addendum

No.	02	**Project:**	WCFPD Station 1
Date:	September 19, 2025	**Project No:**	025-2125

1 A201 NORTH ELEVATION
3/32" = 1'-0"

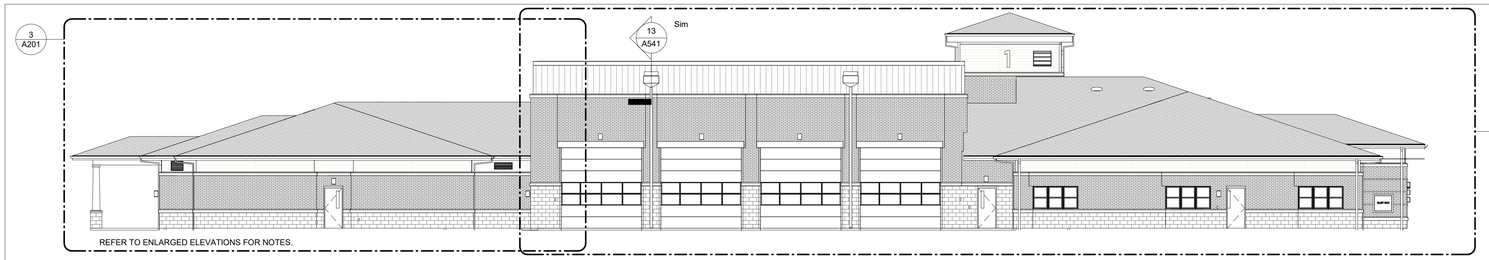
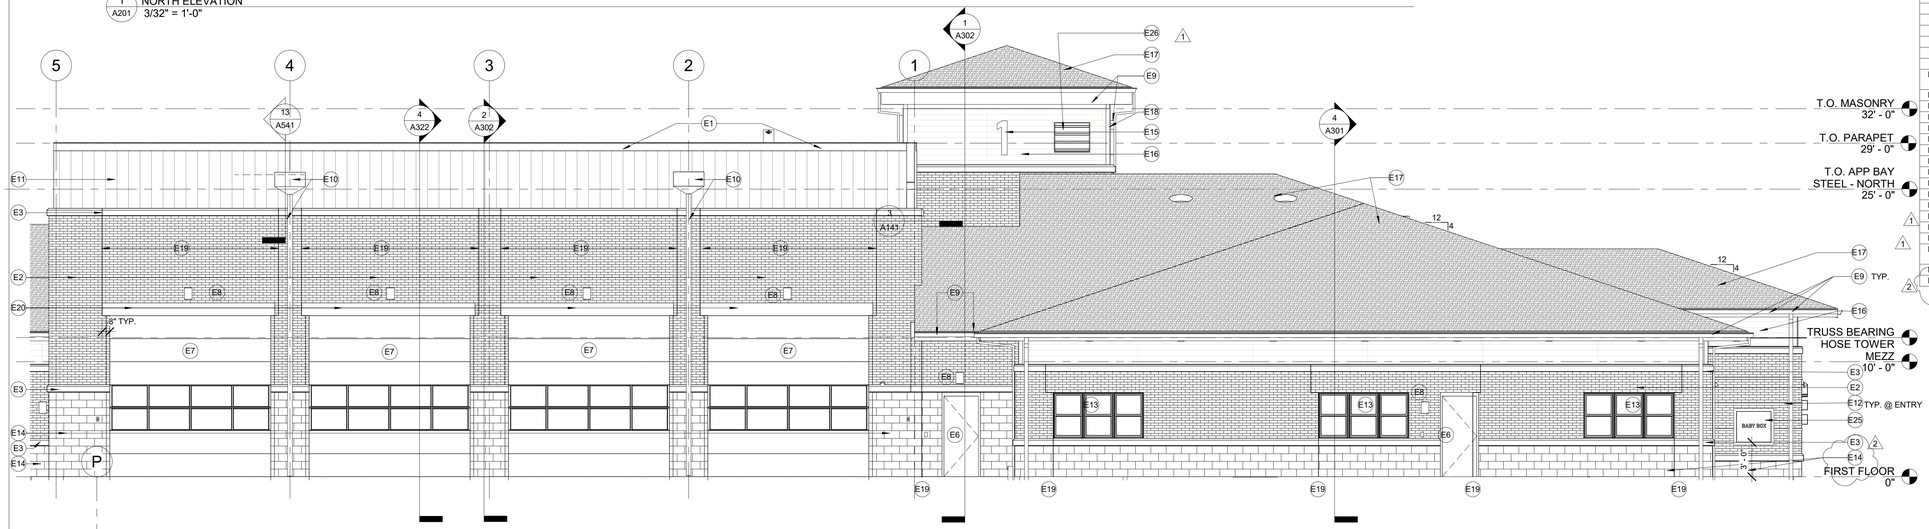
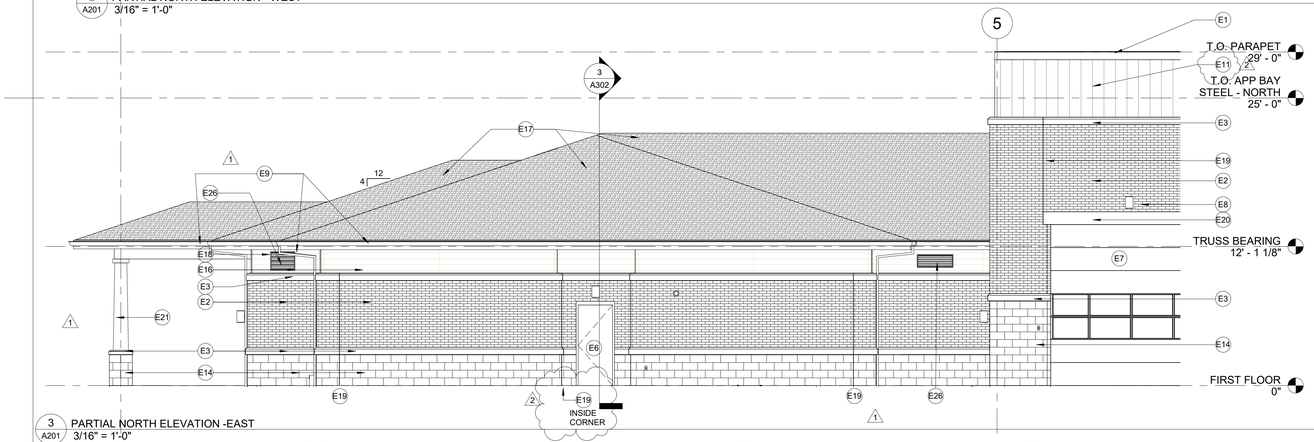
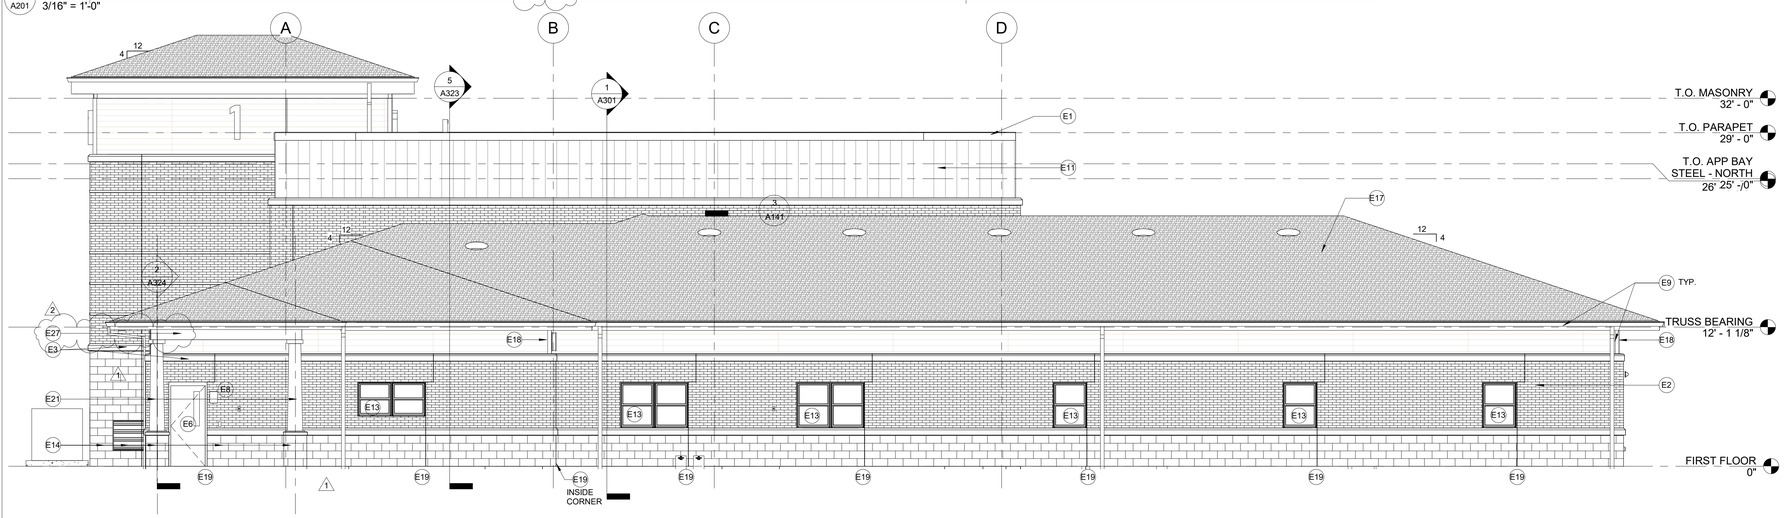
7) Sheet A201 – EXTERIOR ELEVATIONS
   a. ADD Keyed Note E27.
   b. ADJUSTED location of several Keyed Notes so that they are visible.
   c. ADD control joint location.

1 A202 SOUTH ELEVATION
3/32" = 1'-0"

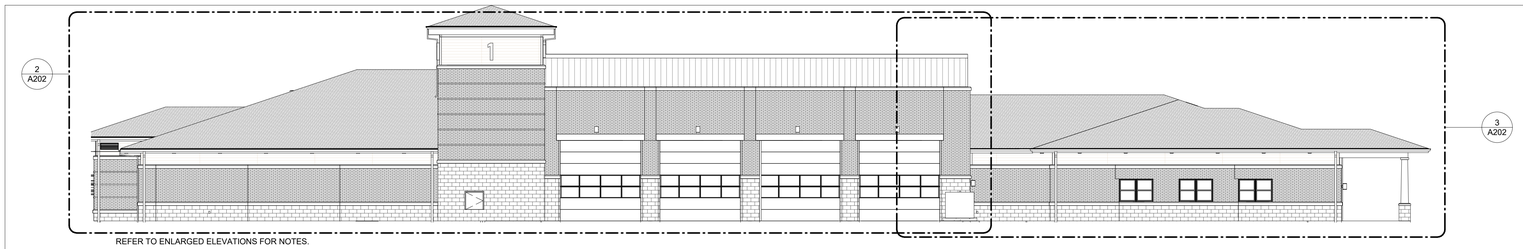
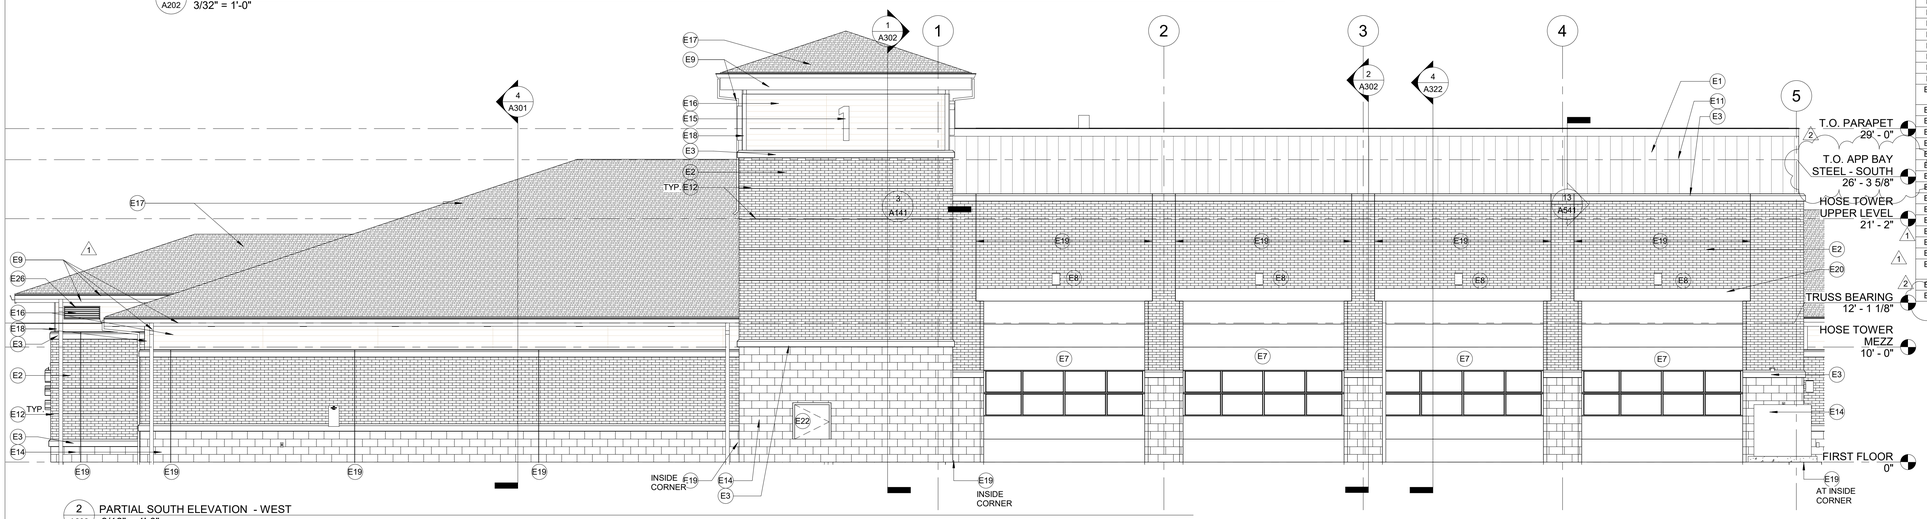
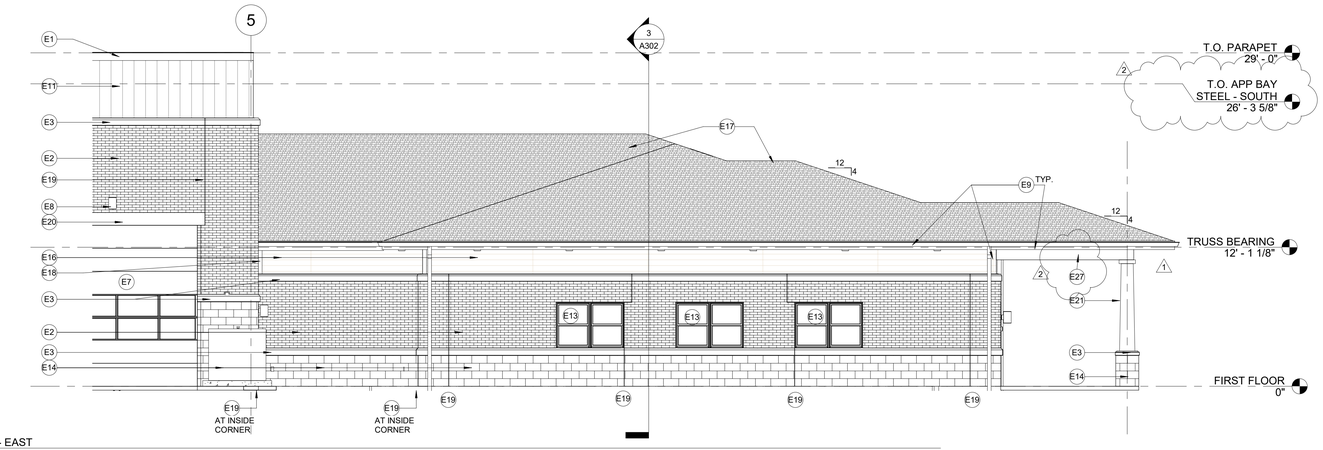
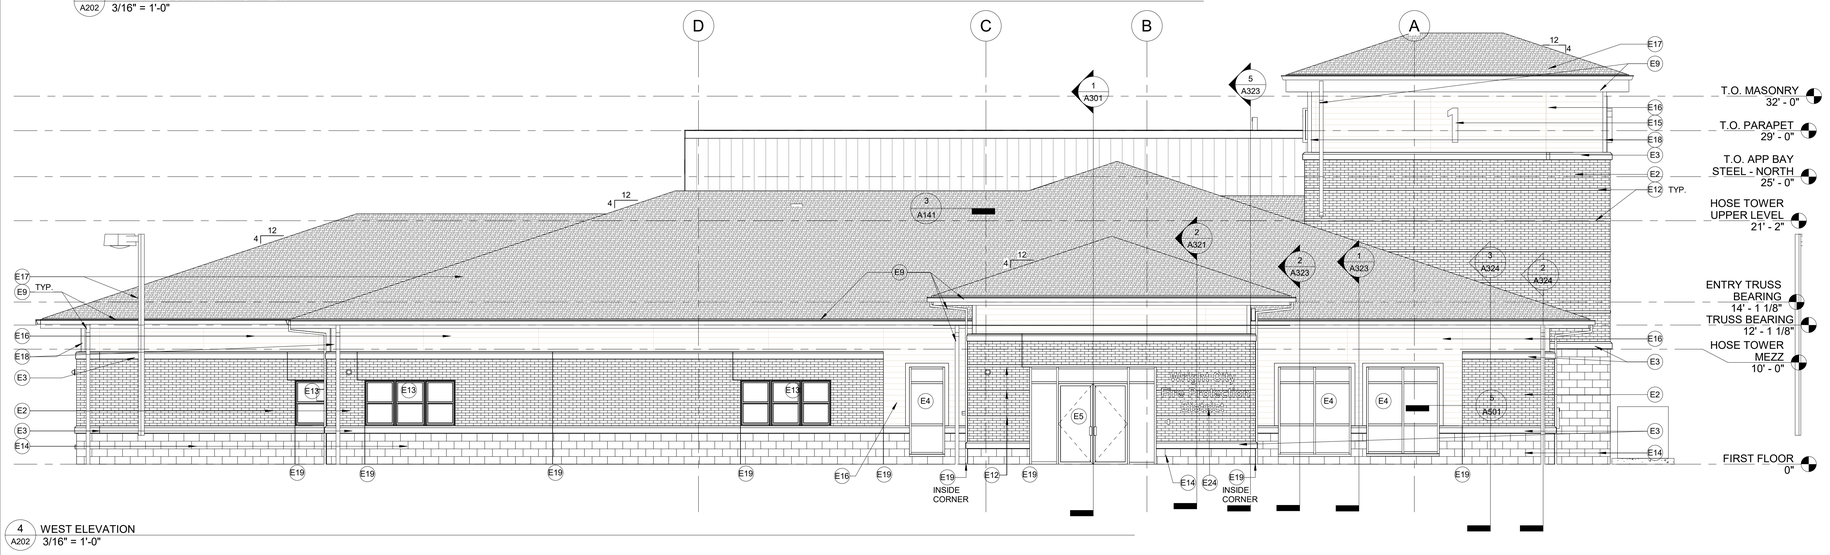
8) Sheet A202 – EXTERIOR ELEVATIONS
   a. ADD Keyed Note E27.
   b. HID several elevation tags to eliminate overlap.
9) Sheet A203 – EXTERIOR ELEVATIONS
   a. ADD Keyed Note E27.

1 A203 EAST ELEVATION - PARTIAL
3/16" = 1'-0"

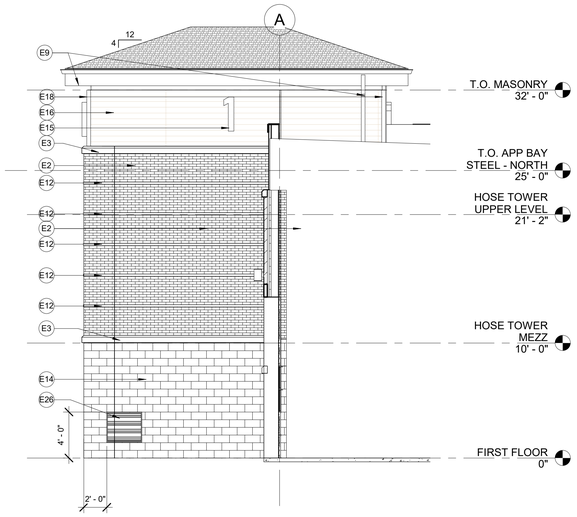
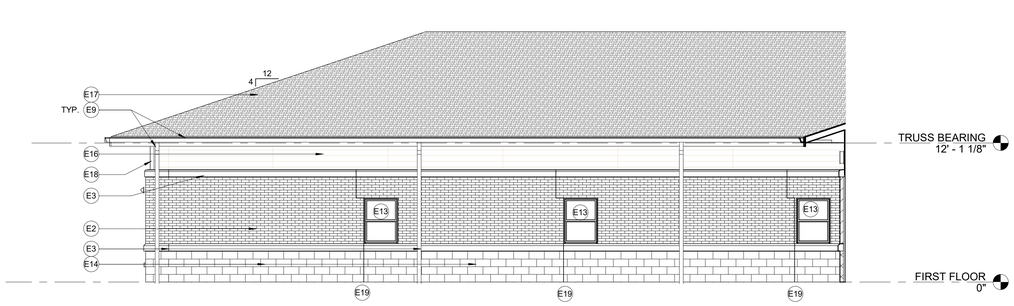
b. ADJUSTED location of several Keyed Notes so that they are visible.
10) Sheet A221 – INTERIOR ELEVATIONS
   a. MODIFIED Transaction Window in Elevation 1/A221 and 6/A221.

1 A302 BUILDING SECTION 3
3/16" = 1'-0"

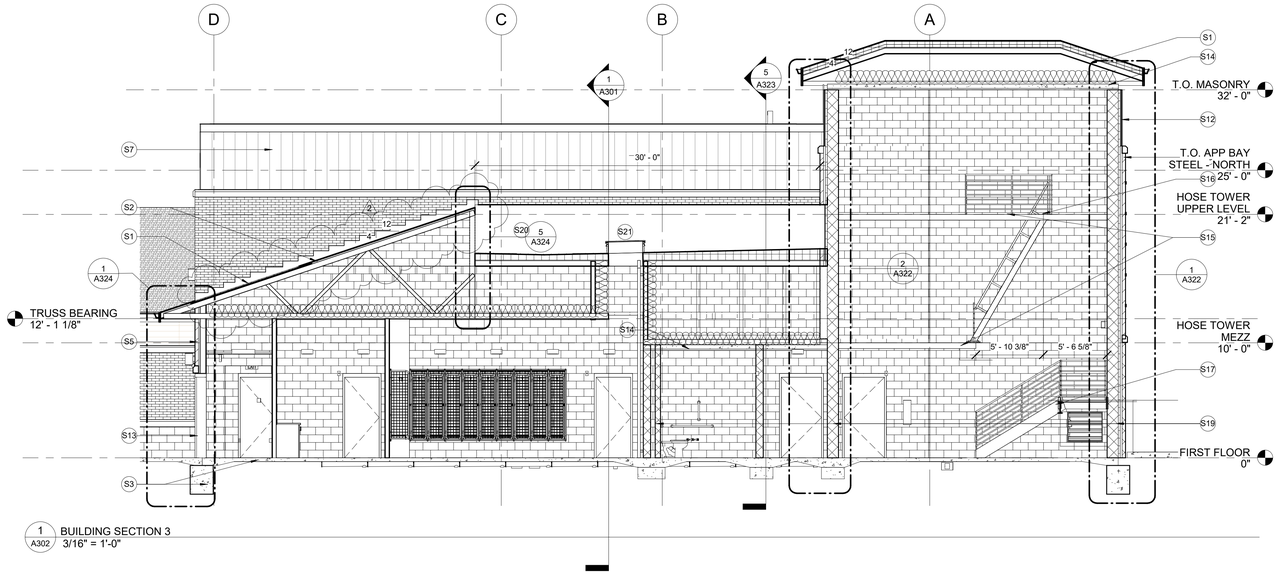
c. MODIFY Keyed Notes E28, E36, E47 and E49
13) Sheet A302 – BUILDING SECTIONS
    a. REVISE Step flashing in Building Section 1/A302.
14) Sheet A321
    a. REVISE wall section 3/321.

2 A322 WALL SECTION 3/4" = 1'-0"

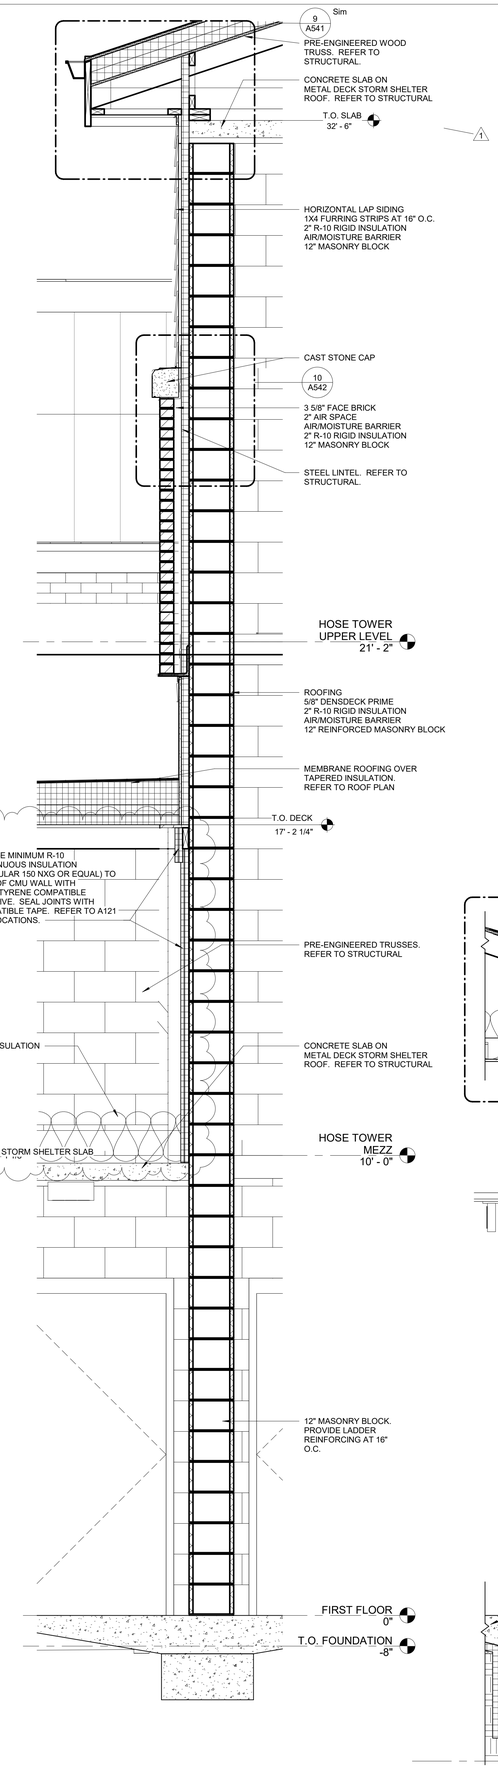
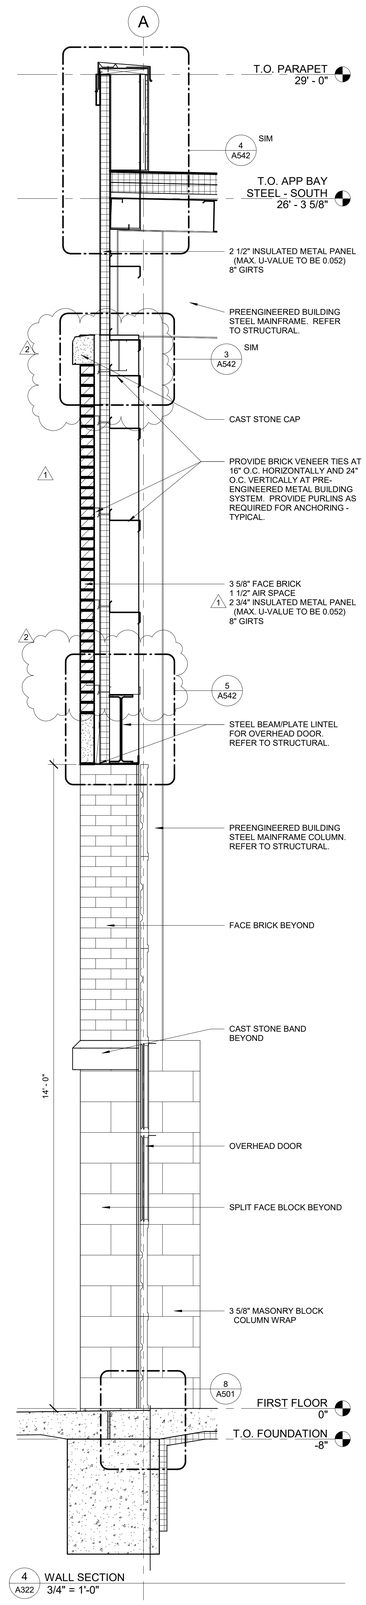
15) Sheet A322
    a. REVISE wall sections 2/322 and 4/322.
16) Sheet A323
    a. REVISE wall sections 3/A323, 4/A323/ and 5/A323
17) Sheet A501 – PLAN DETAILS

1 / A603 PARTIAL EQUIPMENT PLAN - WEST
3/16" = 1'-0"

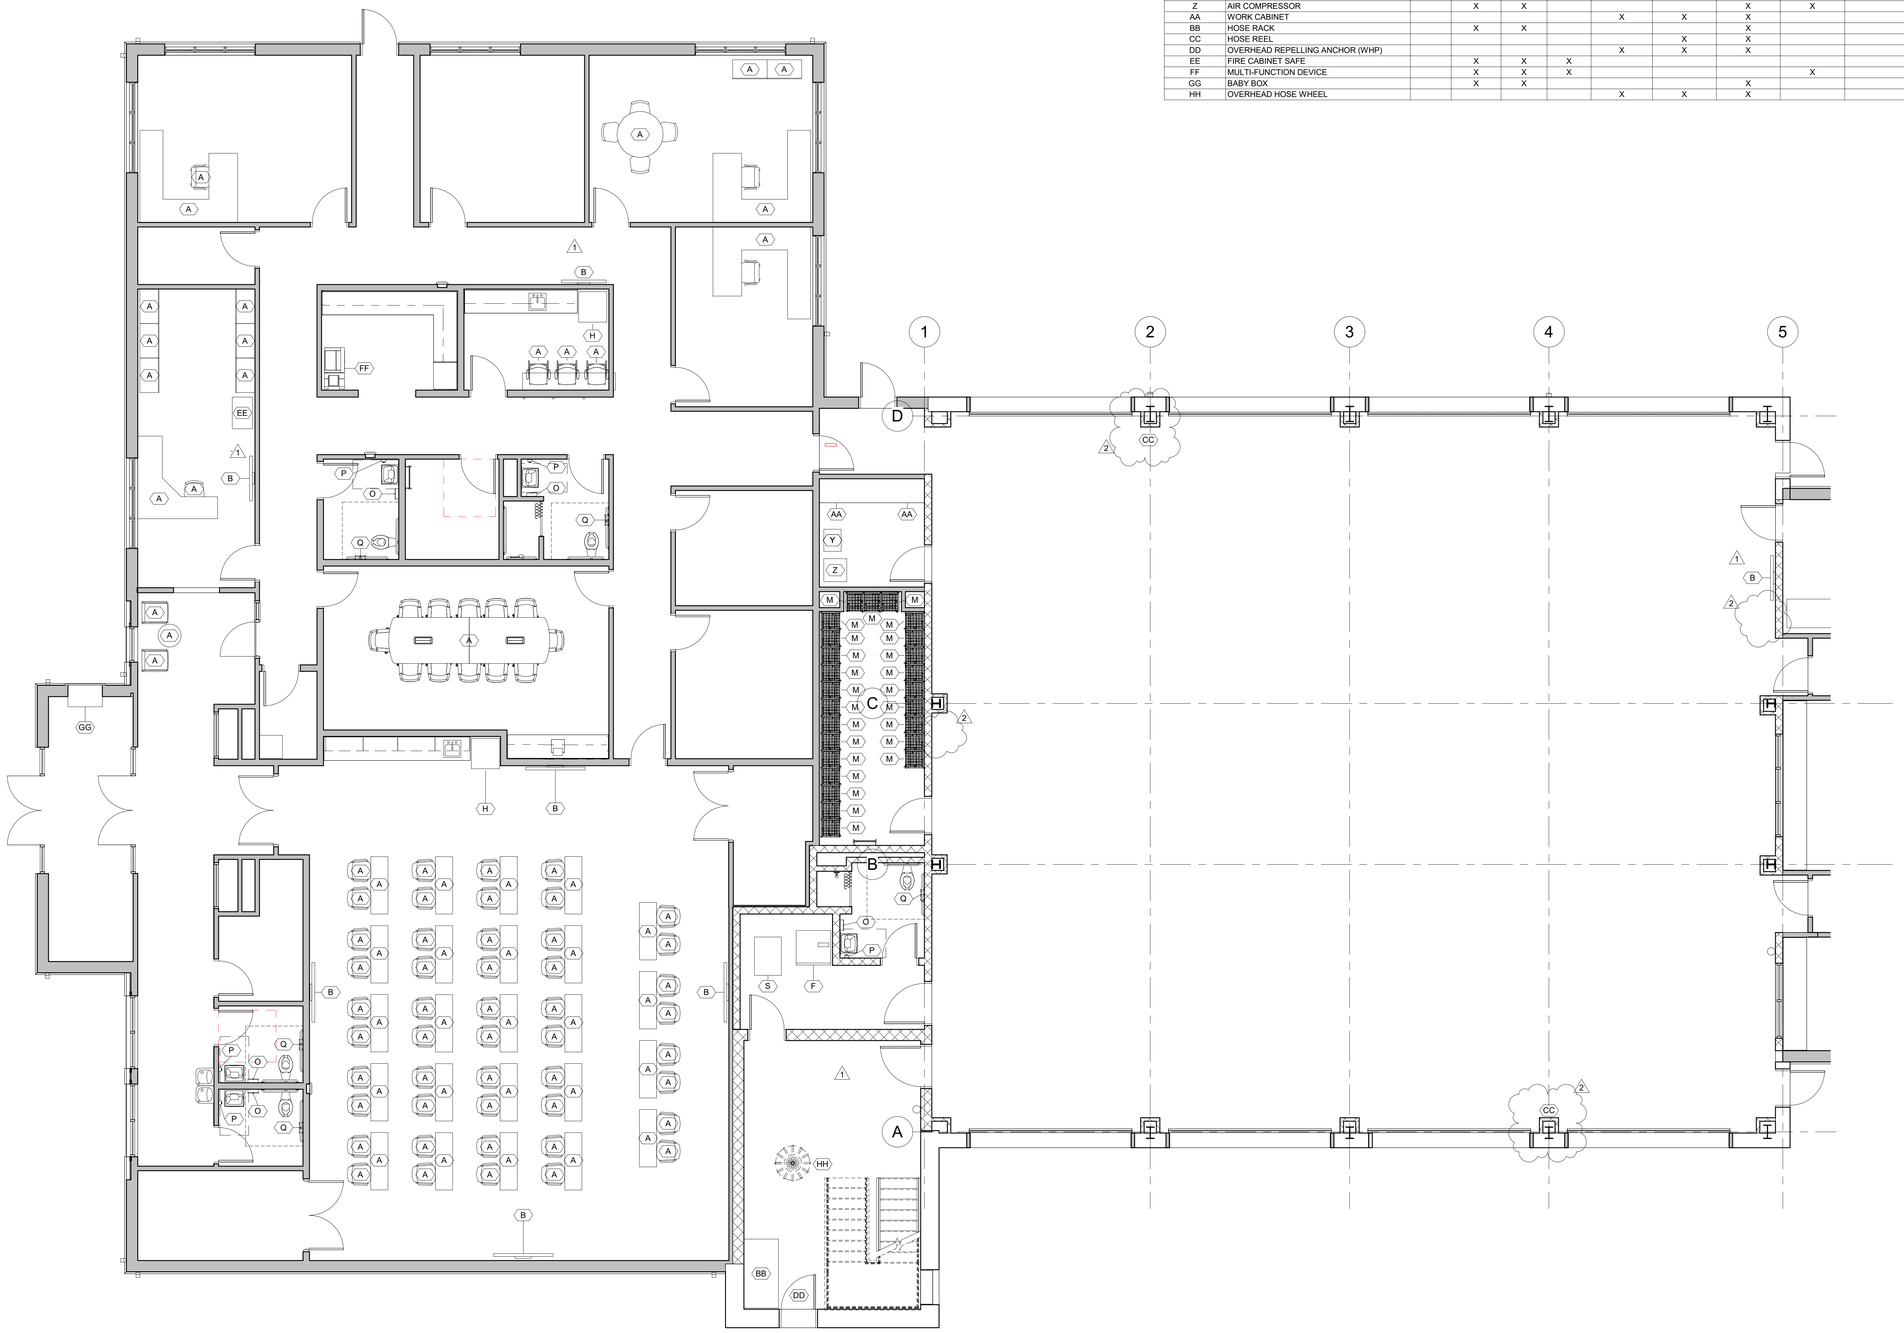
a. REVISE location of hose reel to coordinate with Plumbing documents.
23) Sheet A961 – PARTIAL ROOM FINISH PLAN (WEST) AND LEGEND
    a. ADD finish tags to rooms where they are missing.
